PRODUCT/PROCESS CHANGE NOTICE (PCN)

PCN #: TB1403-01 DATE: April 9, 2014 Product Affected: TSSOP-14, TSSOP-16 shipped in Tape & Reel (Refer to Attachment II for affected part#) Date Effective: July 9, 2014	MEANS OF DISTINGUISHING CHANGED DEVICES: <input type="checkbox"/> Product Mark <input type="checkbox"/> Back Mark <input type="checkbox"/> Date Code Shipment starting from July 9, 2014 <input checked="" type="checkbox"/> Other
---	--

ATTACHMENT I - PCN #: TB1403-01

From: Carrier Tape (P8-195-P16) - Pocket Dimensions

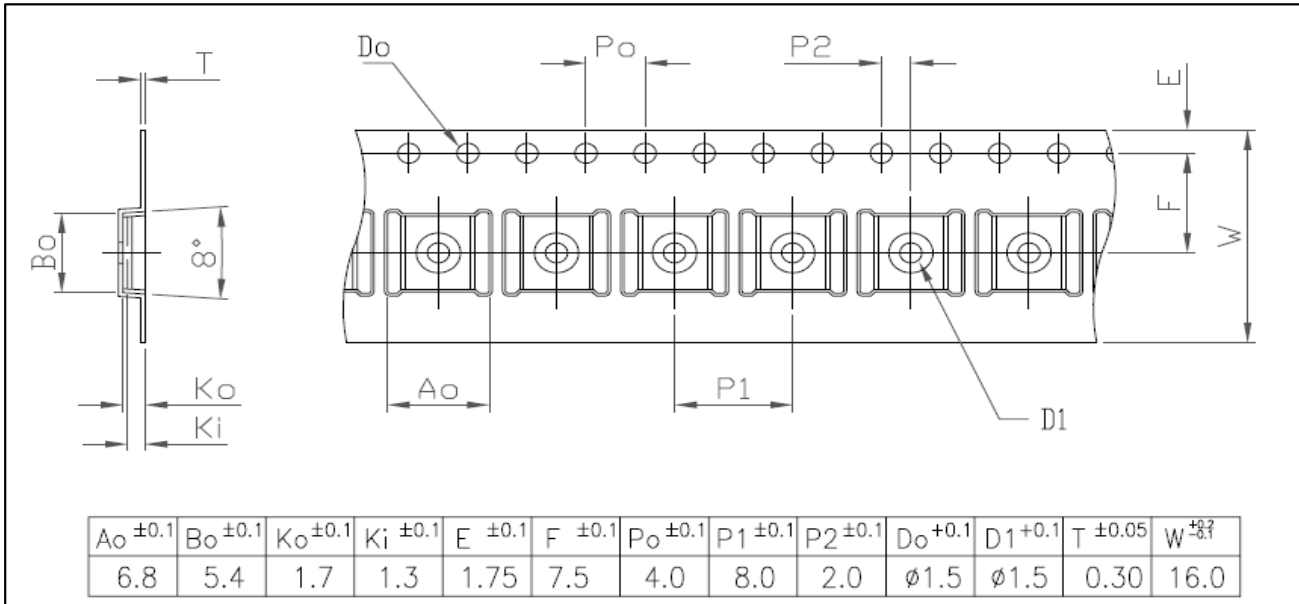
Detail of Change: This notification is to advise our customers that IDT has planned to standardize the following items on TSSOP-14 and TSSOP-16 to only one type as detailed below.

Figure1: Illustration of Carrier Tape Pocket Dimensions

From: Carrier Tape (P8-195-P16)

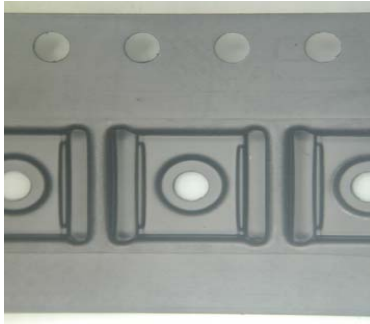
Figure2: Illustration of Carrier Tape Pocket Design

From: 13"/4" Hub Plastic Reel

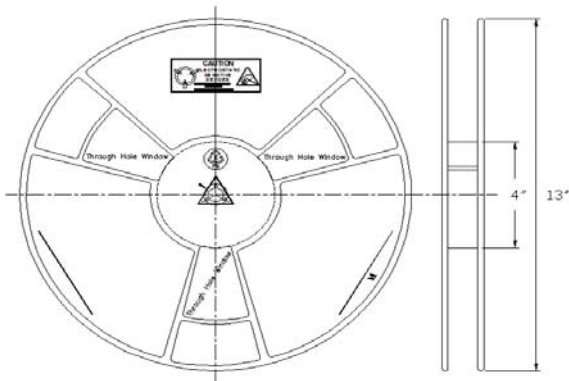
Figure3: Illustration of Plastic Reel
